NARWEE PARKLANDS CARE COMMUNITY

SSDA SUMMARY OF DESIGN CHANGES FOR DPE

Response to Submission Design Report for the Narwee Parklands Care Community

State Significant Development Application (SSD-45024776)

Ground Level

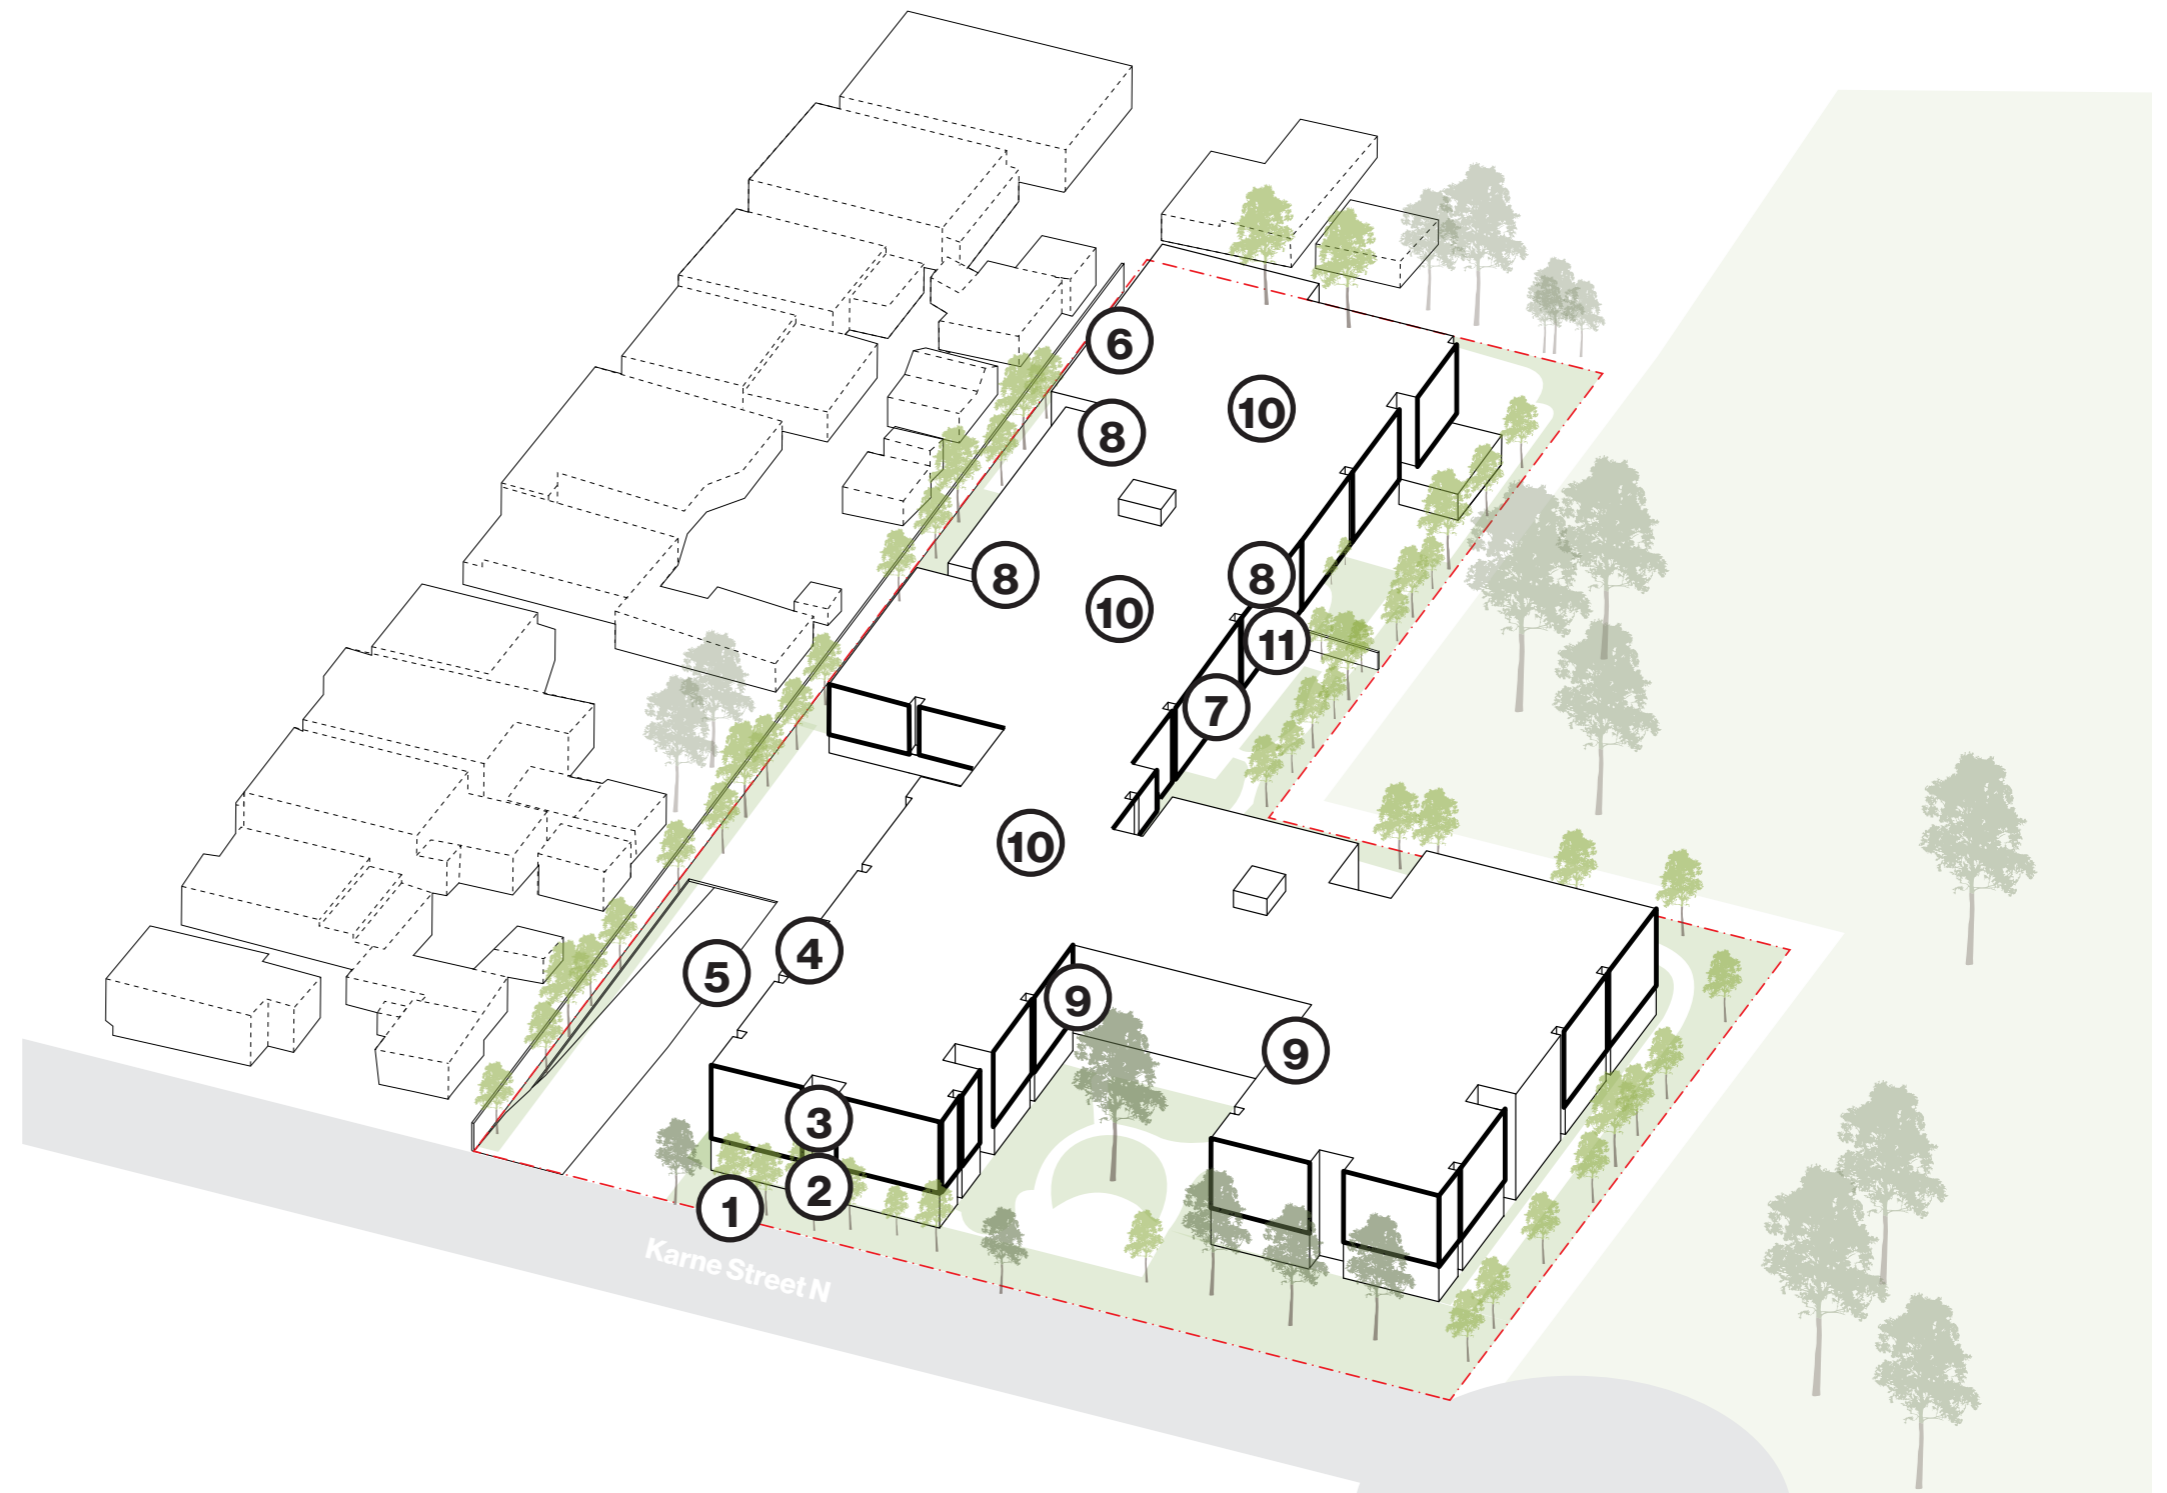
- ① Proposed aluminium trellis gate to conceal fire hydrant and sprinkler assemblies facing Karne Street North.
- ② Fire egress from Basement encroachment upon front setback removed and relocated.
- ③ North-western facade cladding encroachment upon front setback removed.
- ④ Revised design has increased original 400mm wide planter boxes to 900mm wide planter boxes (with 600mm clear planting) along Ground Floor balconies.
- ⑤ Native crawling plants have been proposed along the other side of driveways for screening to soften basement ramps concrete upstands and act as a visual green buffer.
- ⑥ 2 x MCN Beds in wing C located in Ground Floor removed. Creating a better connection to Northern and Eastern courtyard up on the removal.
- ⑦ Training & Function Room with openable doors to connect internal and external and improve flow.

- ⑧ Home F & G / J & K Activity Rooms swapped with single bedrooms to accommodate better visual privacy between the homes.
- ⑨ Home A & B / D & E / H & I bedrooms facing FOH to be provided with privacy screens.

- ⑩ Services plant area revised to 16% with acoustic screen, below the allowable 20% total roof area.
- Services plant and photovoltaic cells to setback 2m from roof edge
- ⑪ Additional staff room at ground level adjacent to Courtyard and Staff Breakout area

21st of June - Proposed Design

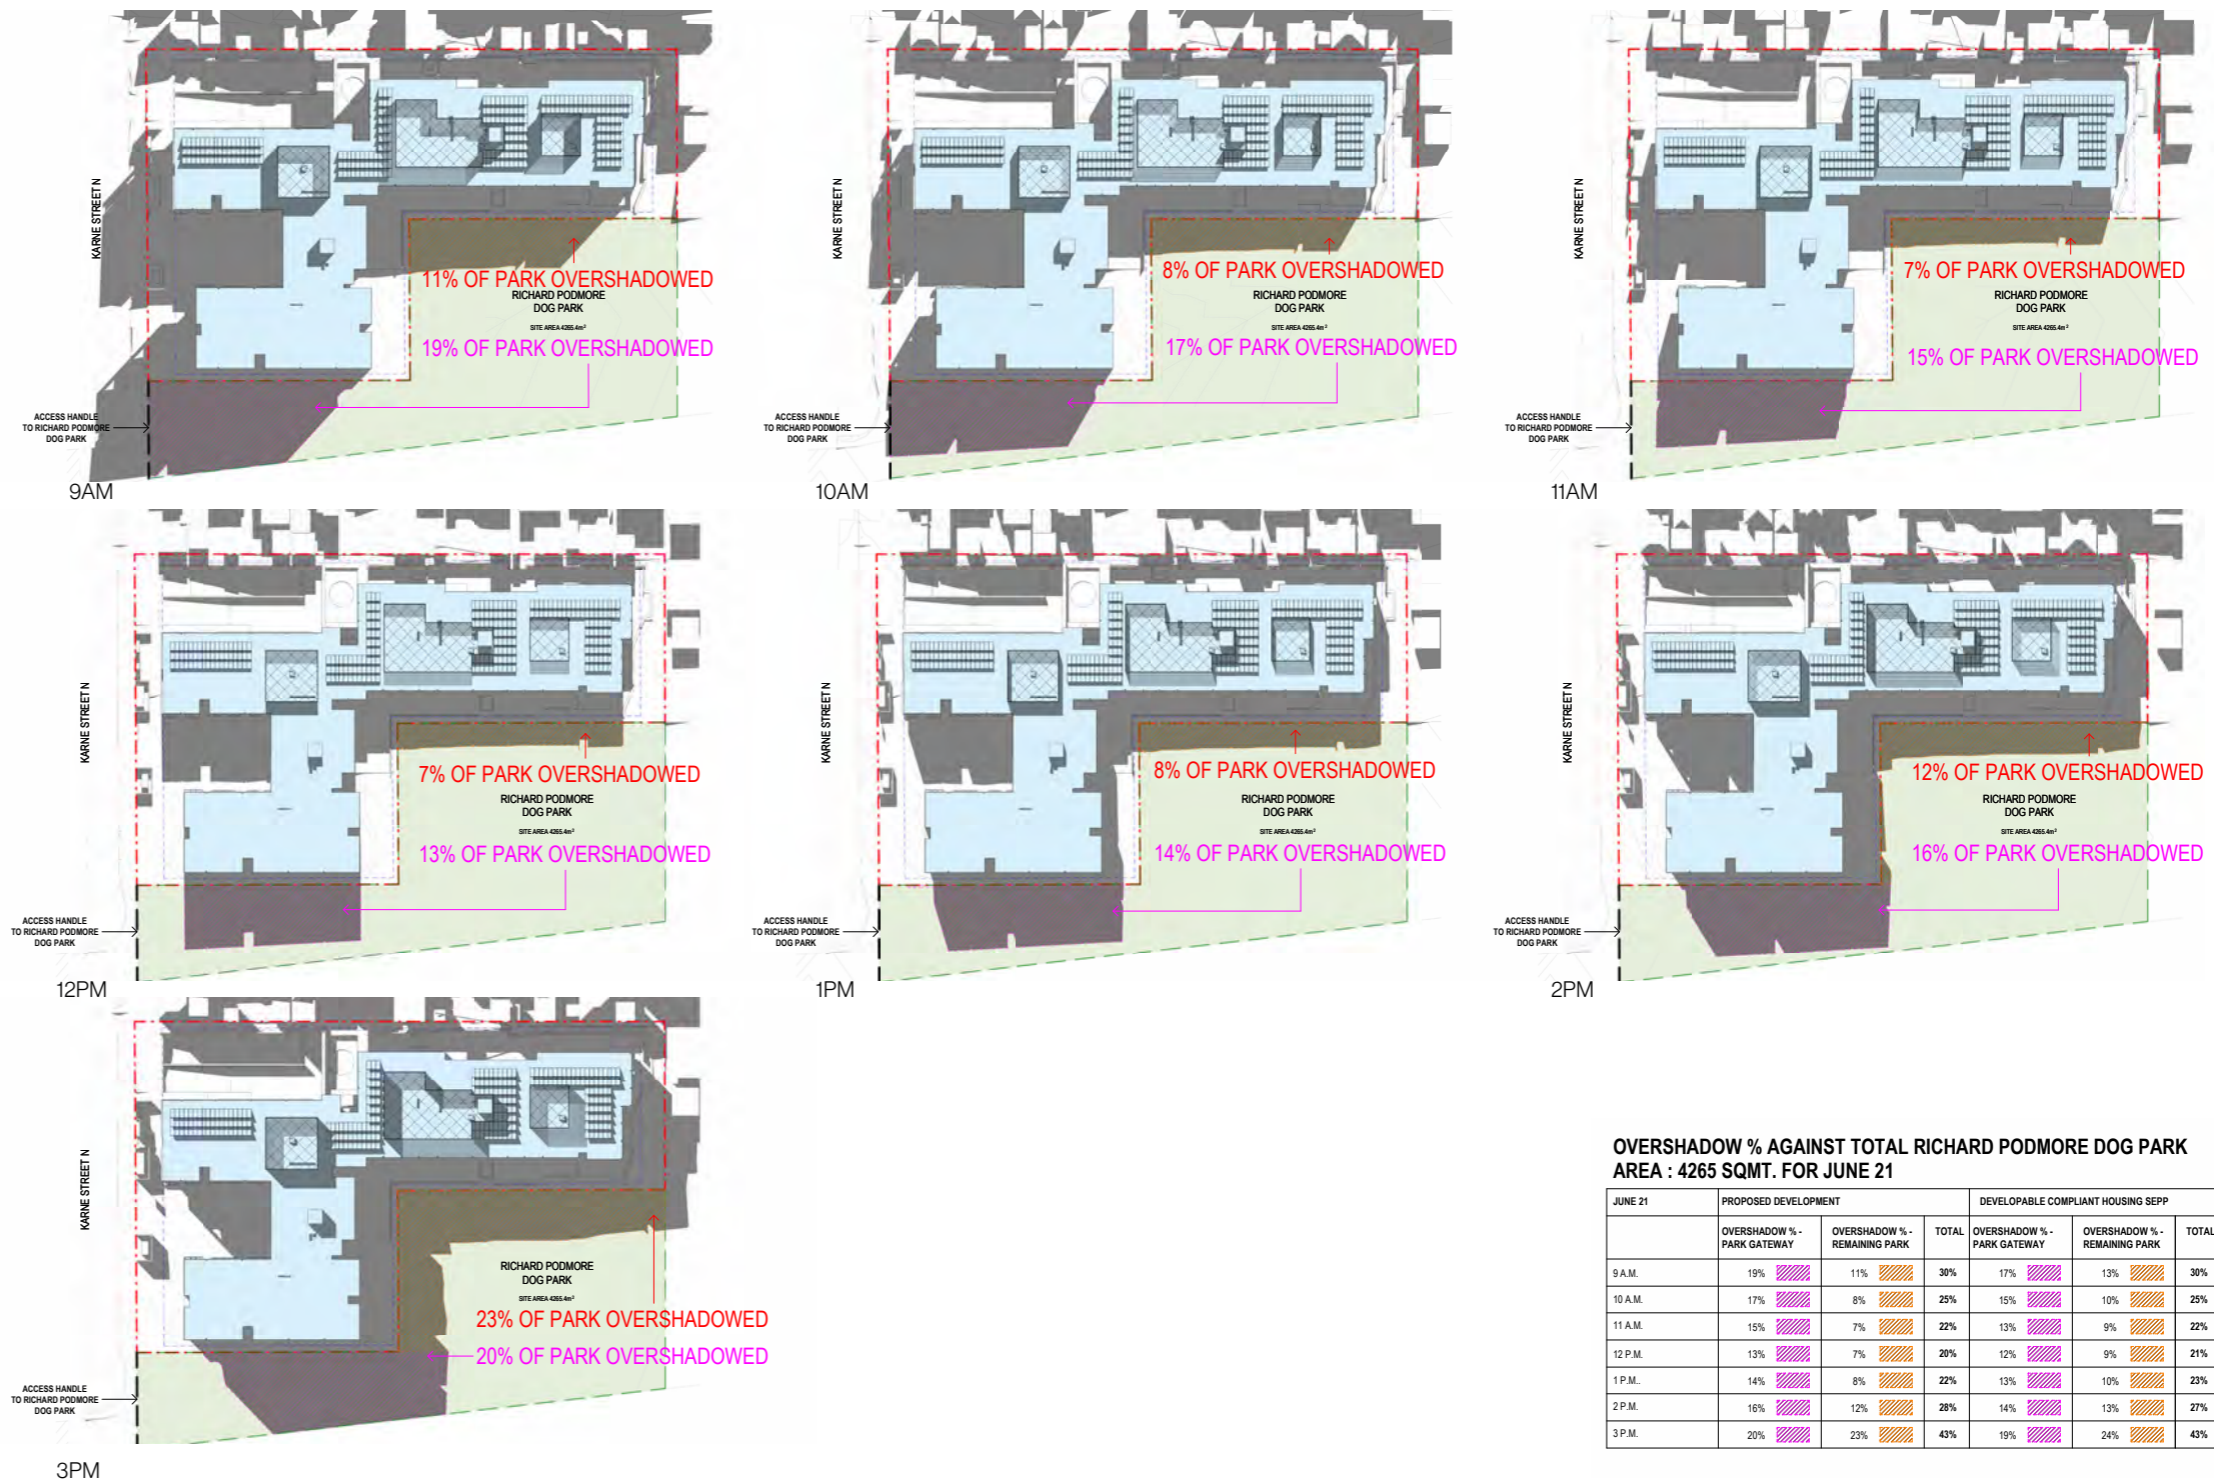
(d) Amended shadow diagrams are to be submitted that remove reference to the previous development on the site. The shadow diagrams must compare the impacts of the proposal against a complying built form.

The adjacent diagrams demonstrate shadows during Winter Solstice hours. The proposed development - overshadowing to the Richard Podmore Reserve has a positive impact in comparison to the complying built form.

21st of June - Developable Compliant Housing SEPP

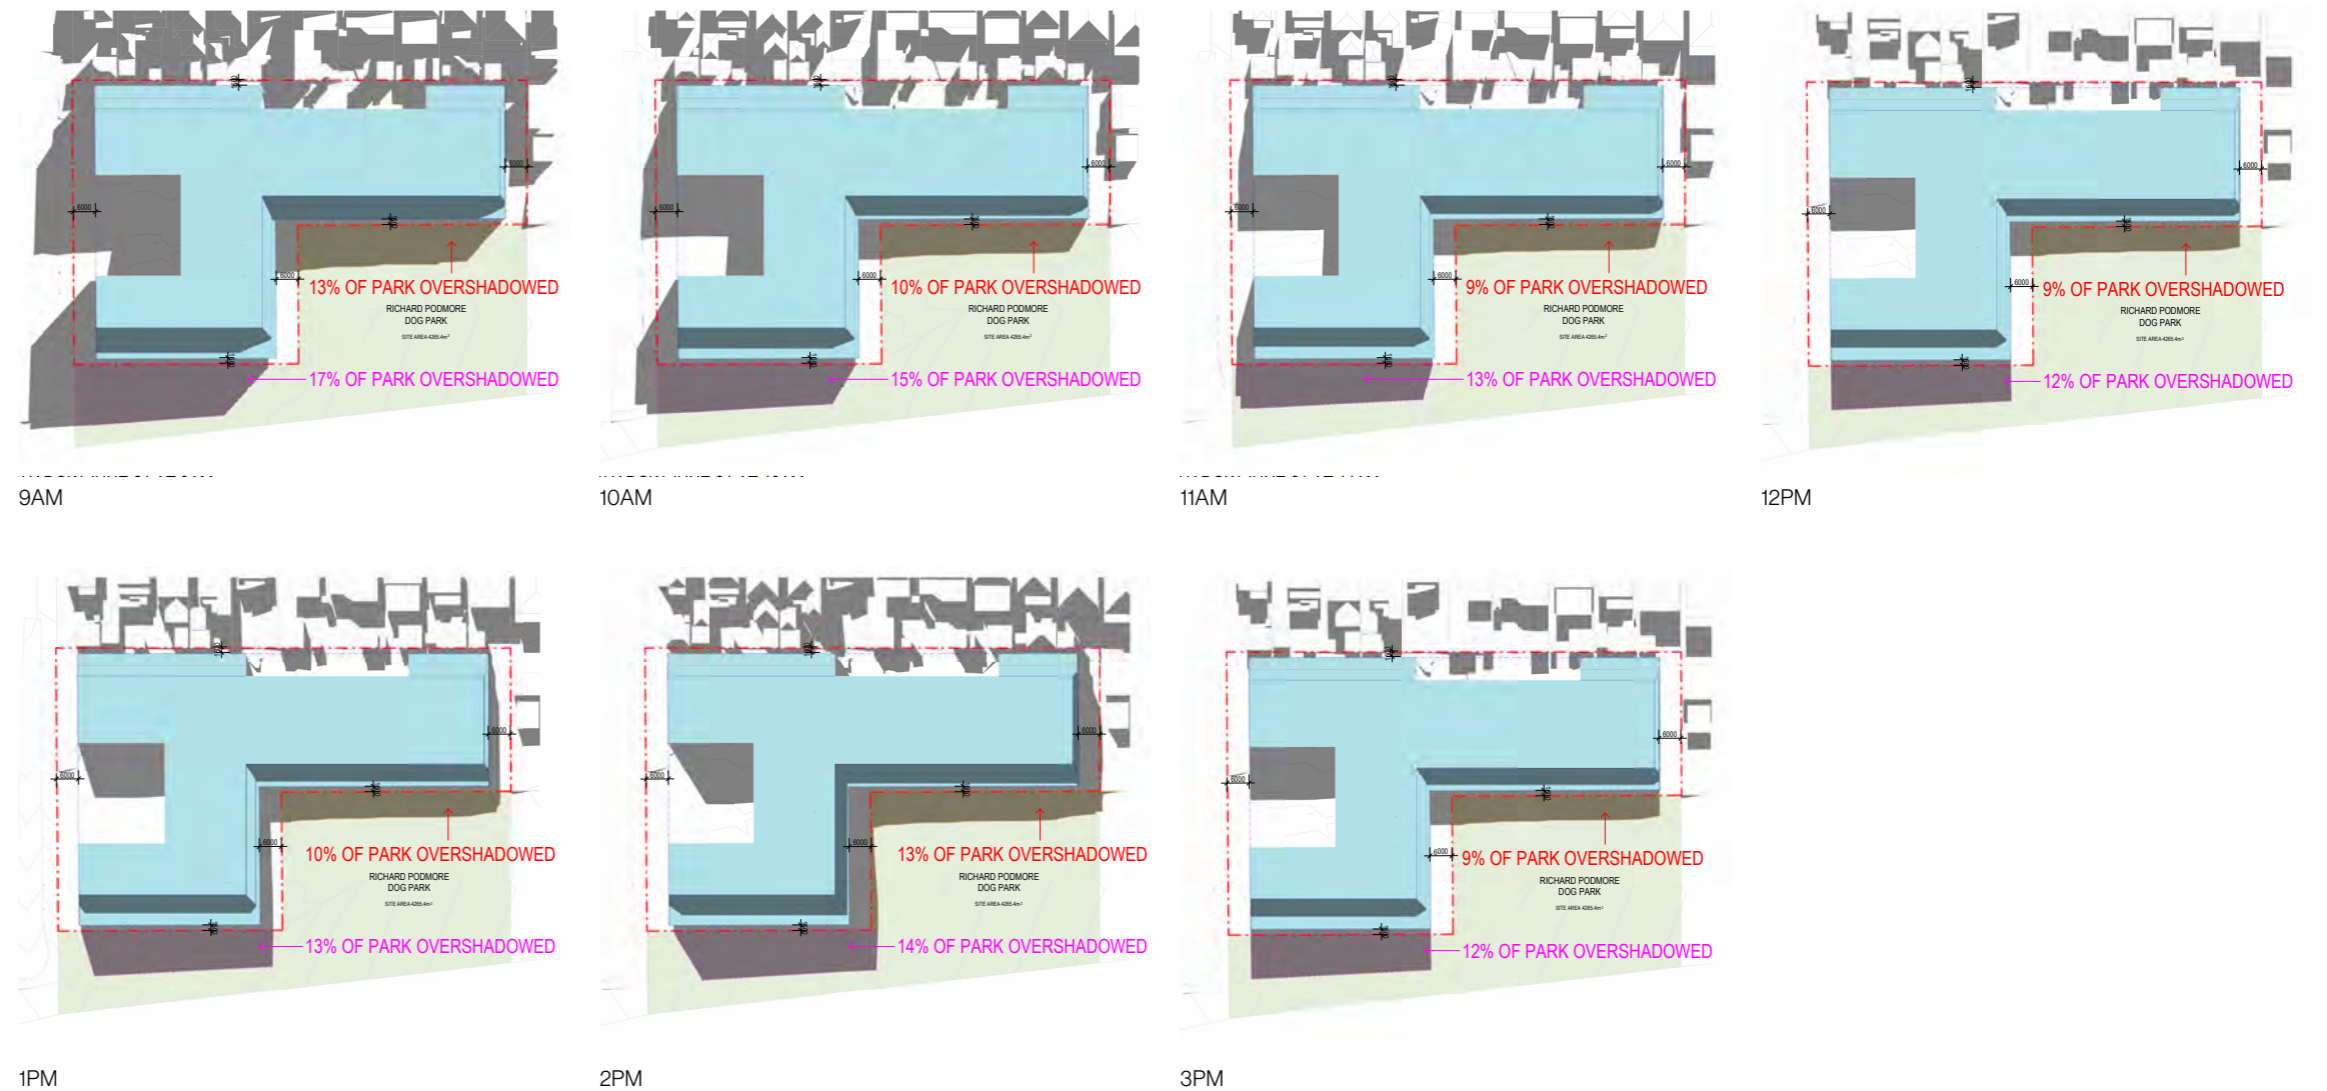
(d) Amended shadow diagrams are to be submitted that remove reference to the previous development on the site. The shadow diagrams must compare the impacts of the proposal against a complying built form.

The Winter Solstice Diagrams demonstrate the Developable Compliant Housing SEPP overshadowing for comparison.
